**CERTIFICATE OF APPROPRIATENESS**

**Applicant:** Sami Gianukos, agent, Jeff Stone, owner.

**Property:** 713 E. 5<sup>th</sup>½ Street, Lot 1, Block 1, Freeland Subdivision. The property is a 6,250 SF (50'x125') interior vacant lot.

**Proposal:** New Construction – The applicant is proposing to construct a two-story single-family residence and garage. The proposal is as follows:

**SITE PLAN  
PROPOSED**

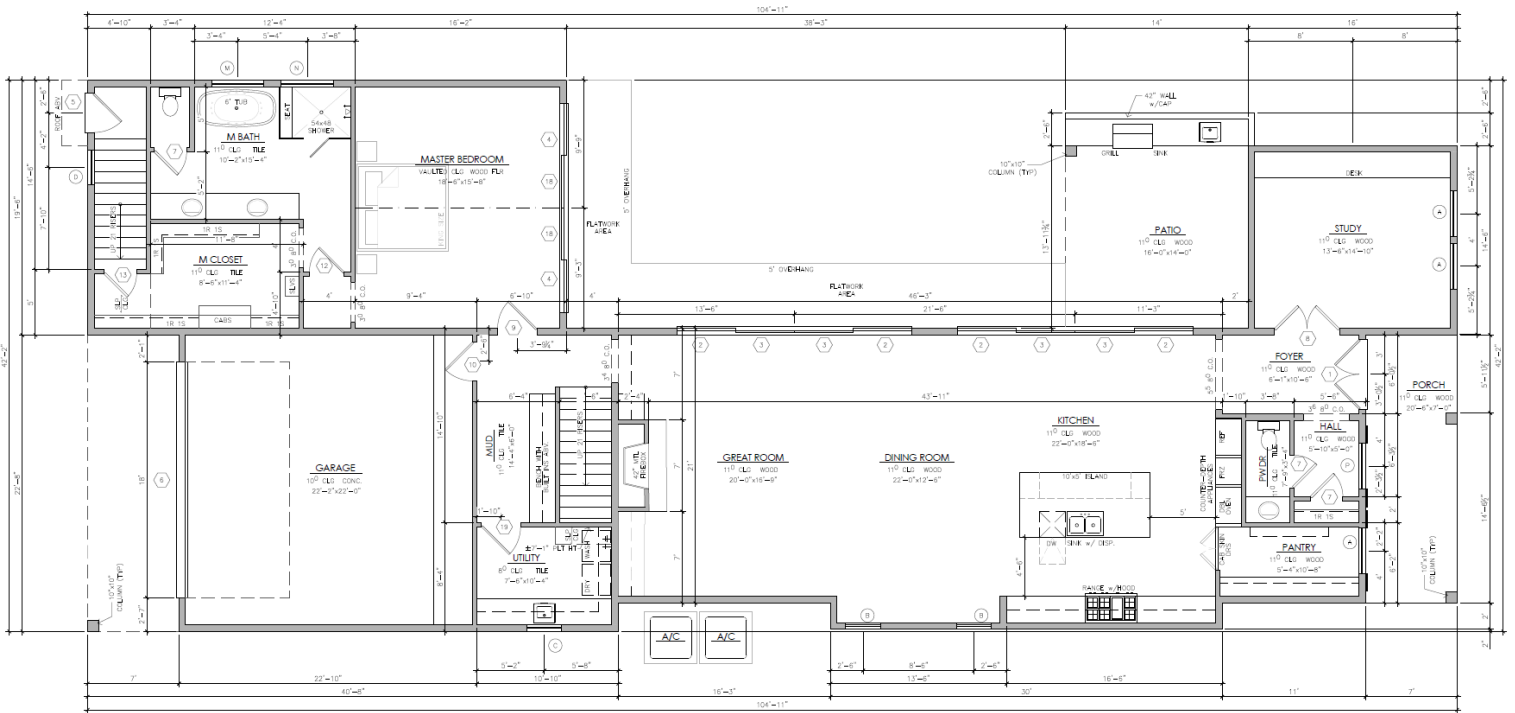
Although the "Square Footage/Lot Coverage" shows it will cover 45.10% of the lot, if you look at the setbacks you will see if will only have 10' on the front (which extends past the setback of the other houses on that block), 10'-1" on the rear, 4'-8" on the east side and 3'-2" on the west next to an existing resident. Just narrow strips on all four sides. That seems like it will cover most of the lot to me.

In that regards, the project submitted for 713 E 5 1/2 Street fails to follow the setting guidelines below. The massive construction takes up the complete lot and fails to match the setback of the rest of the neighborhood. Also all the structures are pier and beam with front porches. That does not appear to be the case on this project. Two story additions are allowed but new construction of two are more stories is considered incompatible. Garages are not to be attached to the building but should be detached and located at the rear of the house. This project again fails to meet that standard and does not follow the rhythm of the Freeland Historic District.
